Access Compliance Report Public Rights-of-Way (Curb Ramps)

Main Street: RIBERA_RD Cross Street: REATA_RD Location: E

ADA ID: RPRK211118132209 Ramp Type: Type 1 - Perpendicular Initial Pass/Fail: Pass Overall Compliance: No Severity Score: 0

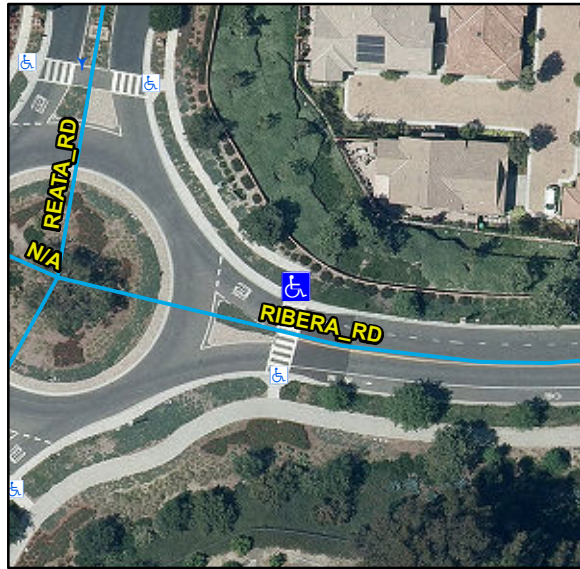
Possible Solutions:

Remove & Replace Gutter.

R304.5.3, STD 1115
